REDMOND URBAN AREA PLANNING COMMISSION

COLTON CROSSING MASTER PLAN, SUBDIVISION, MINOR VARIANCE

PROJECT: COLTON CROSSING
PROJECT LOCATION: REDMOND, OR
CLIENT: DUNLAP FINE HOMES

JOB NO. 23-165
DRAWN BY: CPF
DRAWING: **MP2.2**

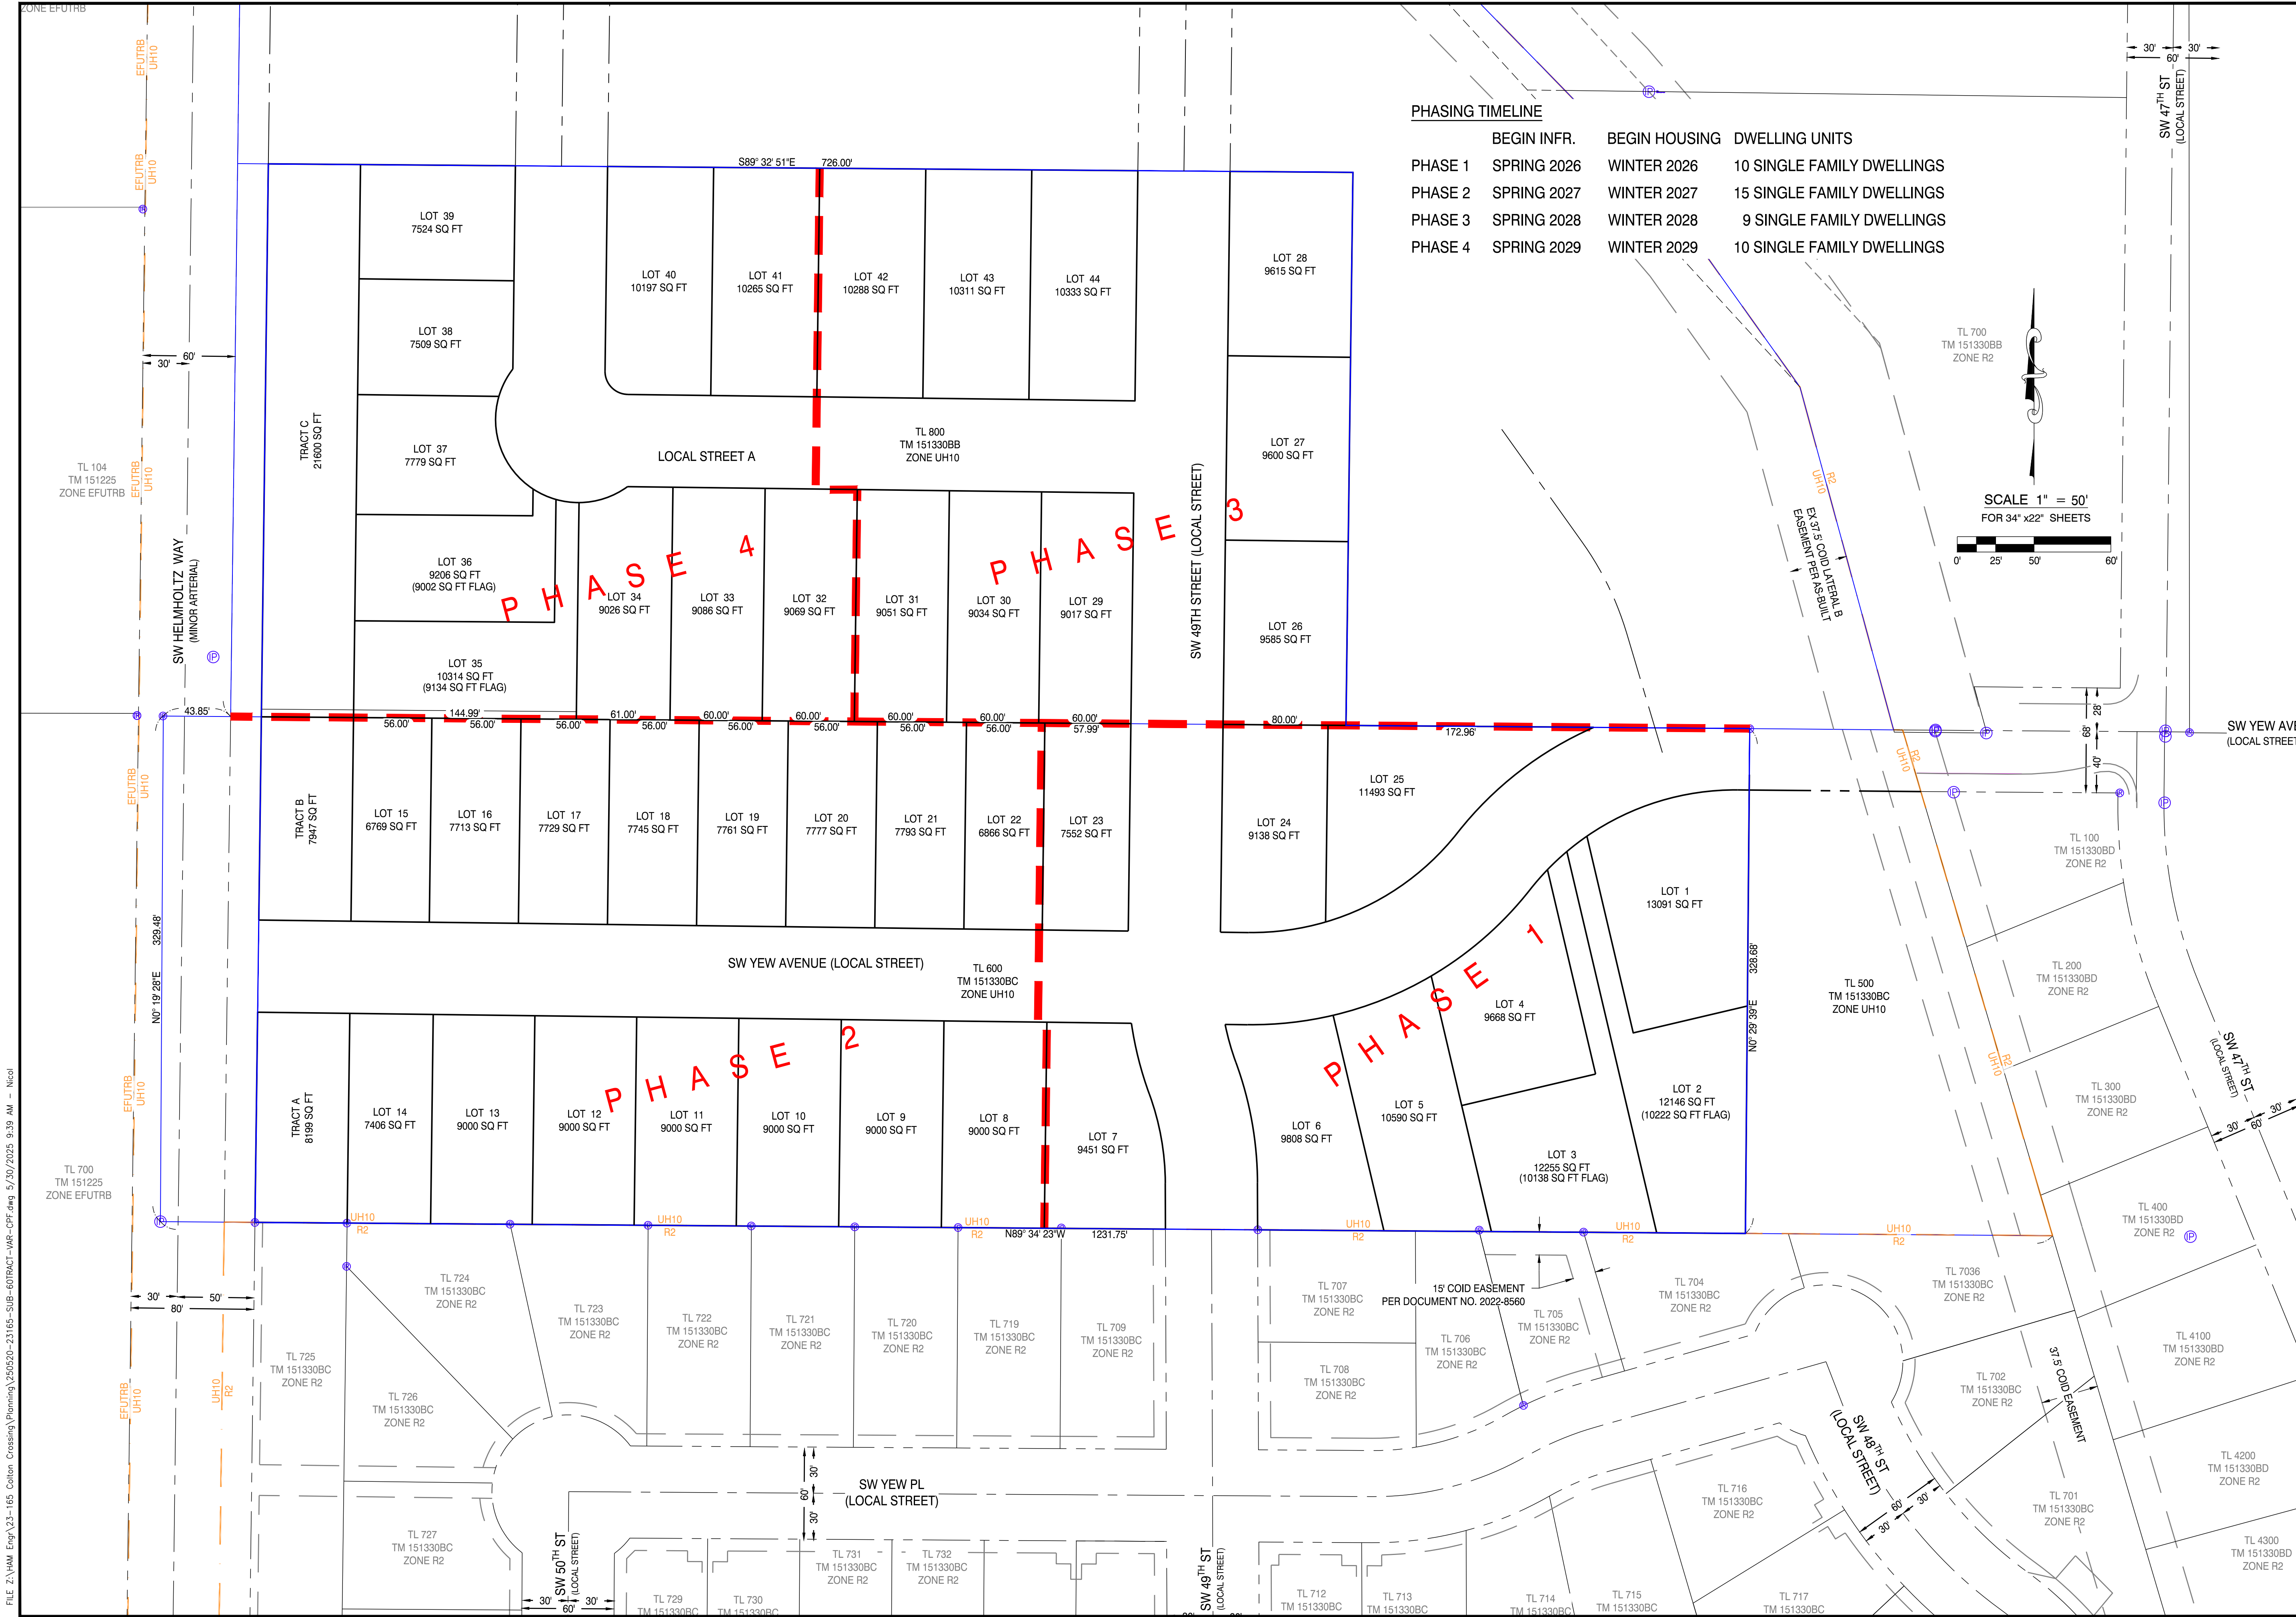
I noticed on the Site Plan, - Drawing MP2.2 there are 3 "Tracts" labelled A,B and C.

FIRE APPARATUS ACCESS:

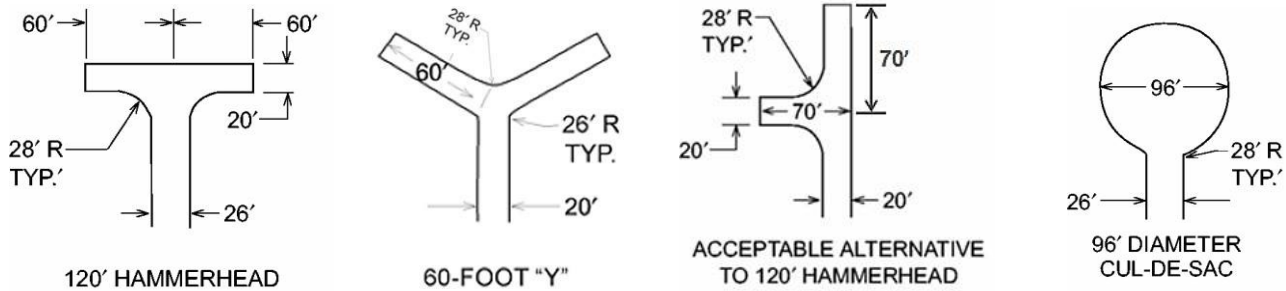
1. **FIRE APPARATUS ACCESS ROAD DISTANCE FROM BUILDINGS AND FACILITIES:** Access roads shall be within 150 feet of all portions of the exterior wall of the first story of the building as measured by an approved route around the exterior of the building or facility. An approved turnaround is required if the remaining distance to an approved intersecting roadway, as measured along the fire apparatus access road, is greater than 150 feet. (OFC 503.1.1)
2. **DEAD END ROADS AND TURNAROUNDS:** Dead end fire apparatus access roads in excess of 150 feet in length shall be provided with an approved turnaround. Diagrams of approved turnarounds are shown below: (OFC 503.2.5 & D103.1)

Local Street A exceeds 150 Feet and would require a turnaround at the end or prove through auto turn that the eyebrow neat to lot 37 would be adequate.
